RE: Comments for Prologis South Park; Application number 201509280070

DEVELOPMENT PLANS FOR PROLOGIS SOUTH PARK

GRADING & DRAINAGE PLAN C3.03

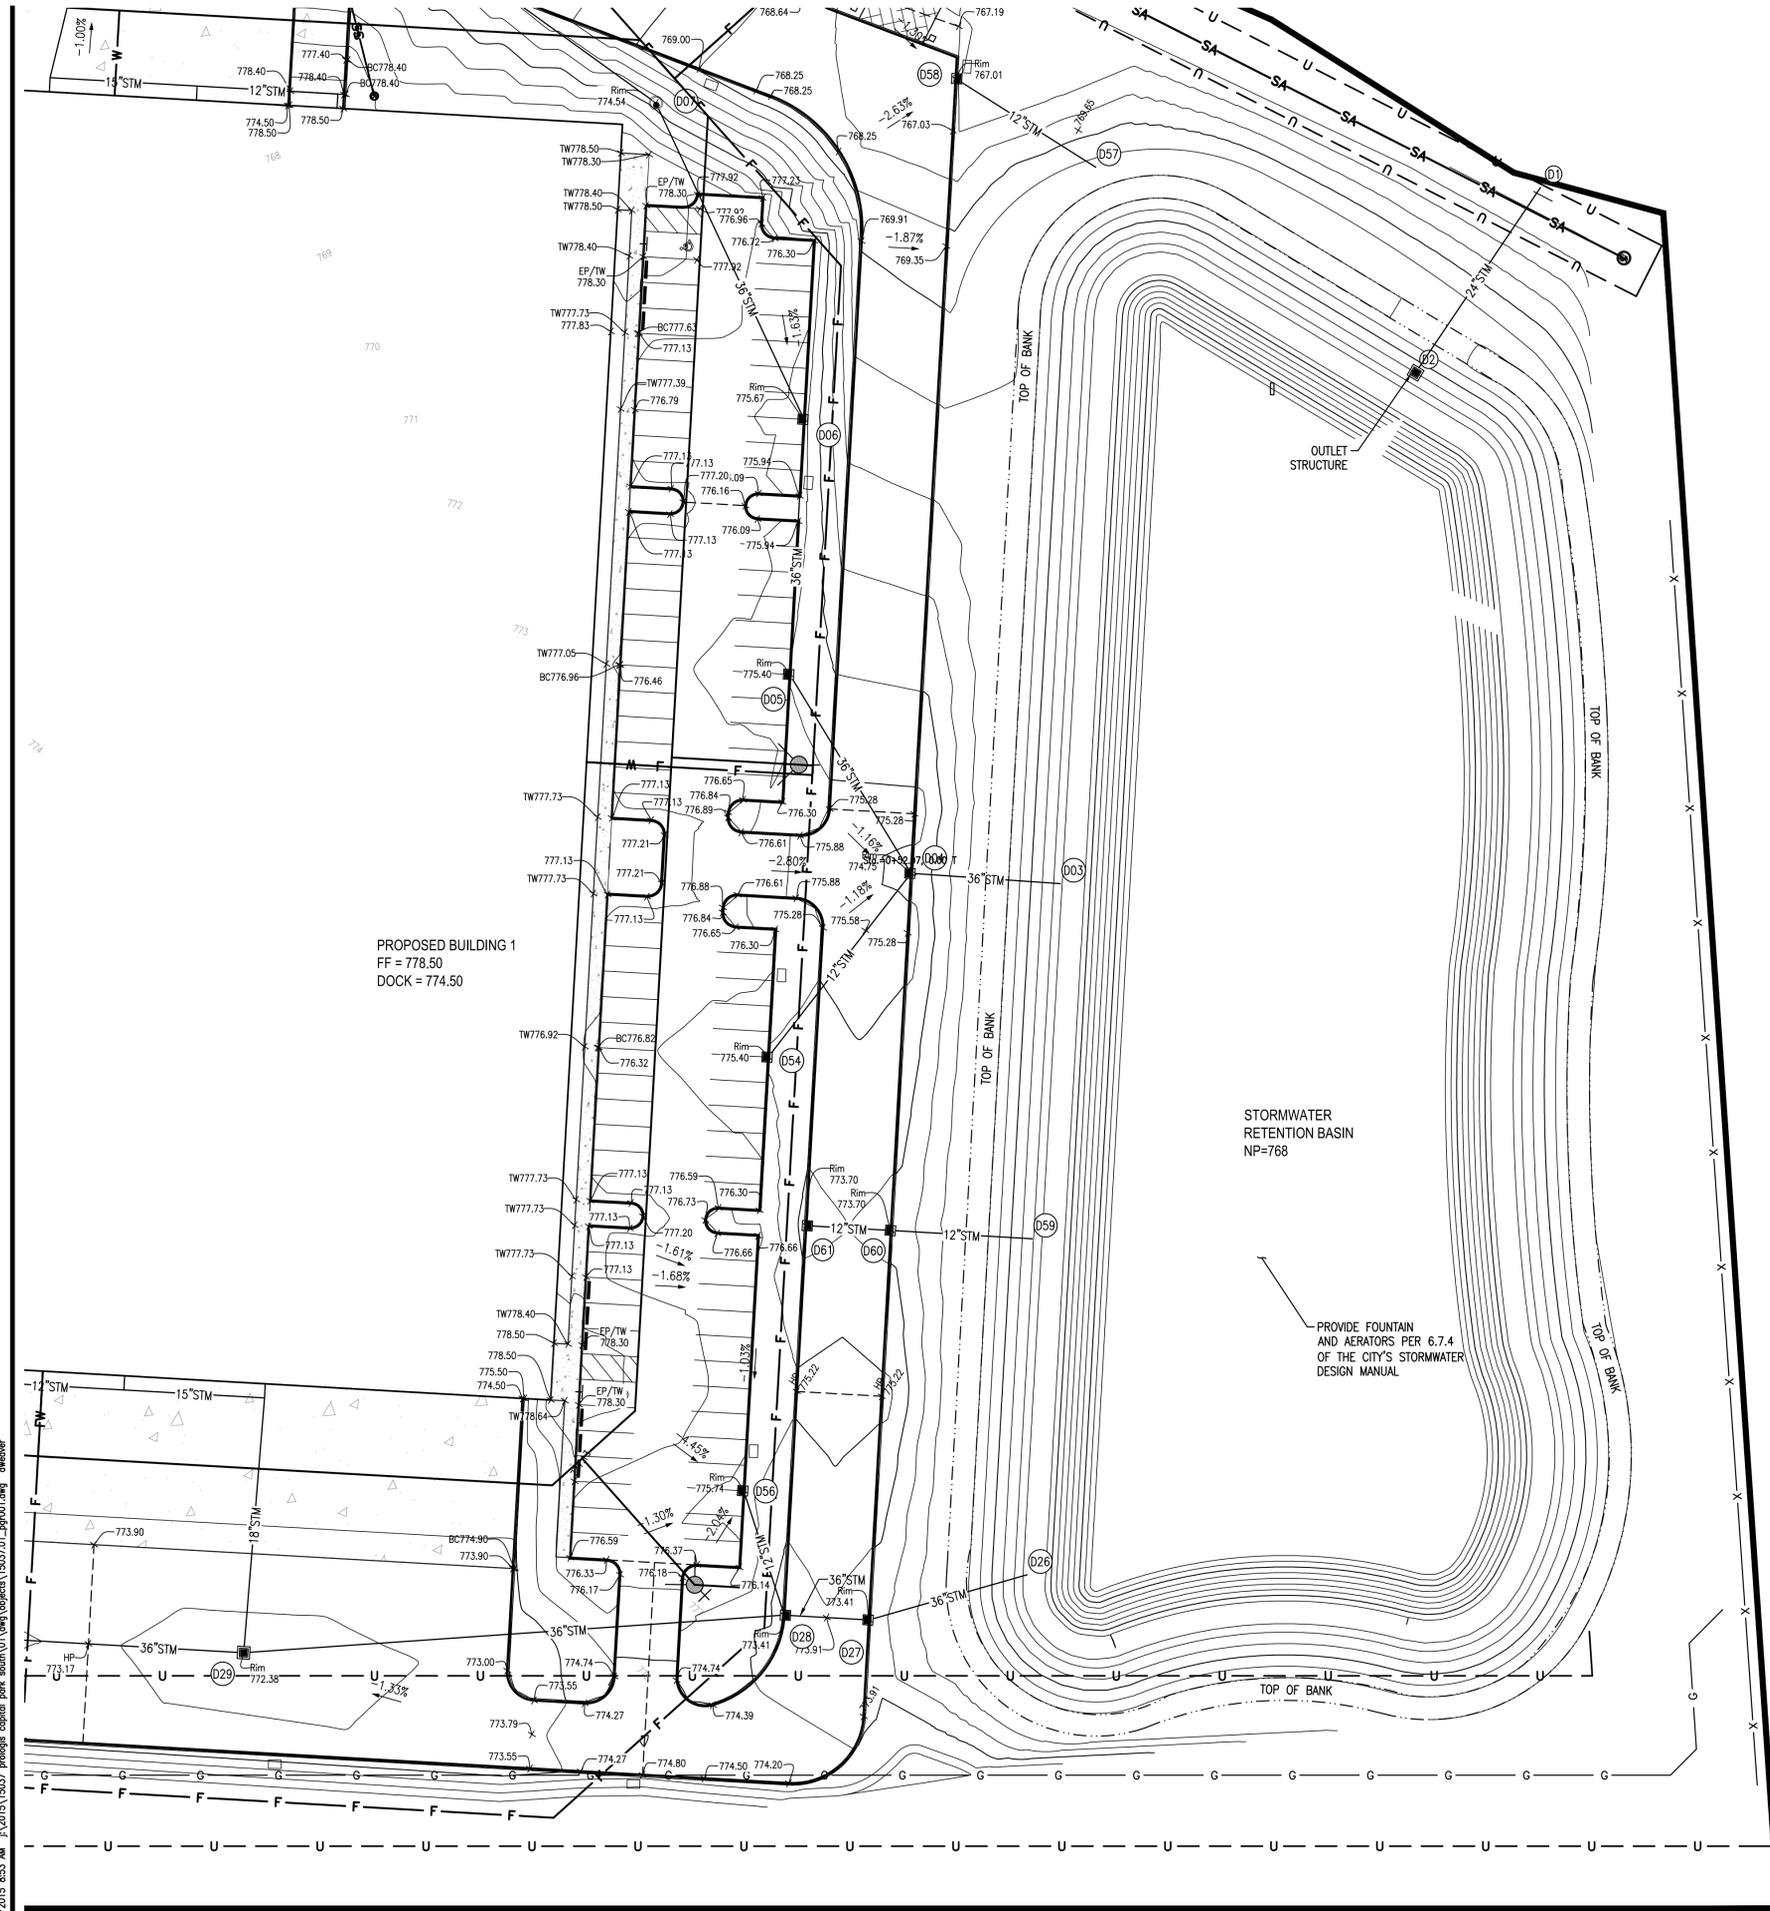
- Pond shall include fountains and aerators as per 6.7.4
 - Pond design requires an 8' path to allow this site feature to be an amenity to the property/workers. Please incorporate trail into site design.

PROVIDE FOUNTAIN
 AND AERATORS PER 6.7.4
 OF THE CITY'S STORMWATER
 DESIGN MANUAL
